Wiring deltas easYgen-3100/3200/P1/P2 versus easYgen-3100XT/3200

Clemens - 2026-11-12 - easYgen-3000XT

AC current sensing:

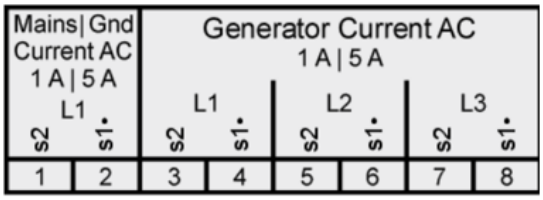
Old easYgen-3000 line had part numbers for ../1A or ../5A.

easYgen-3000XT can be used for ../1A or ../5A current sensing

Analog Inputs:

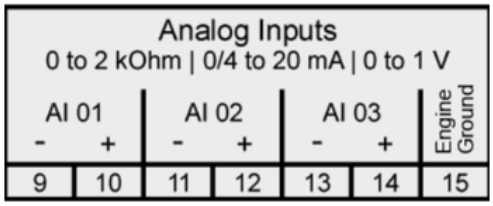
In old easYgen-3000 resistive senders up to 500Ohm and 0/4-20mA were supported. In 3000XT resistive inputs were increased to 2000Ohm and 0-1VDC senders are possible as well.

Analog Outputs:

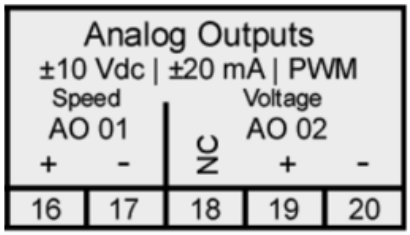
In old easYgen-3000 controls a short link was required to convert current signal into voltage signal.

In 3000XT this is done internal so easYgen-3000's terminal 15 is used in 3000XT for engine ground.

Communication Interfaces:

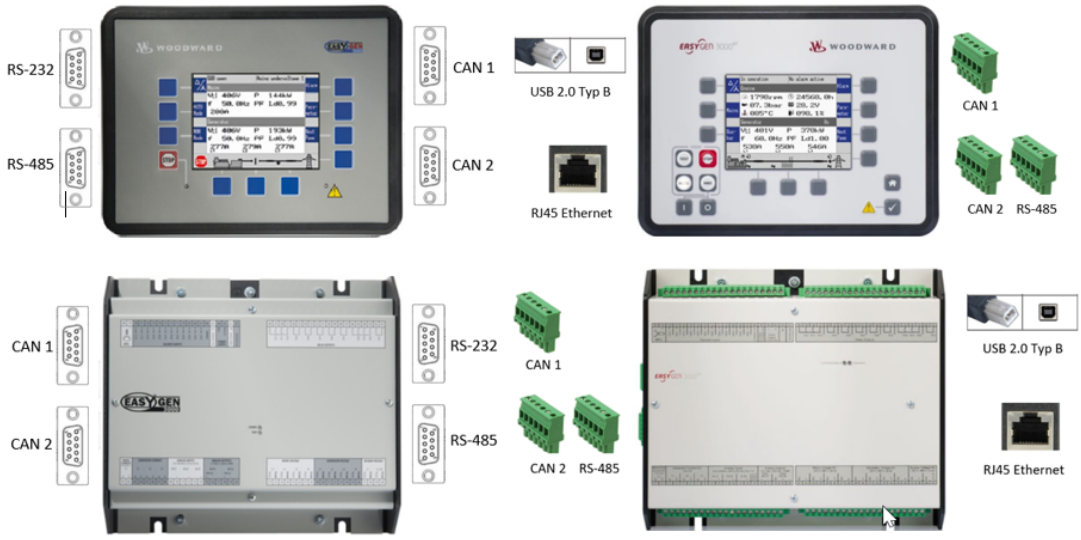
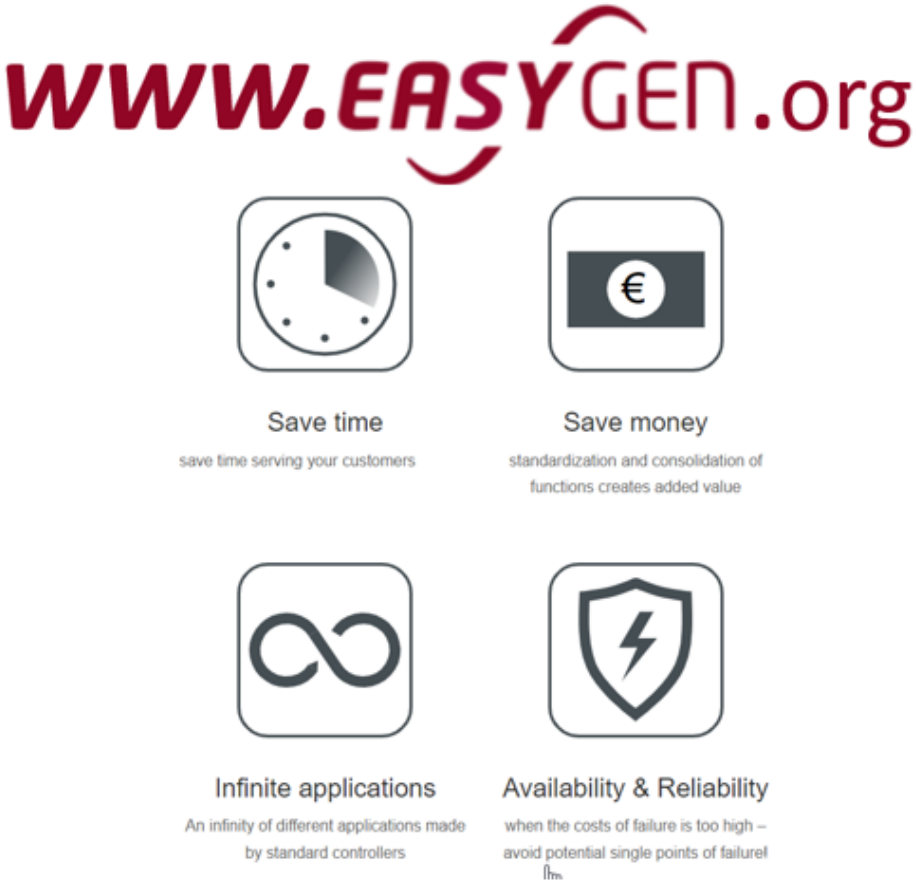
Old easYgen-3000 had D-sub sockets. RS232 port is used for Toolkit configuration. In easYgen-3000XT RS232 port was replaced by a USB 2.0 service port socket. In easYgen-3000XT D-sub sockets are replaced by terminals
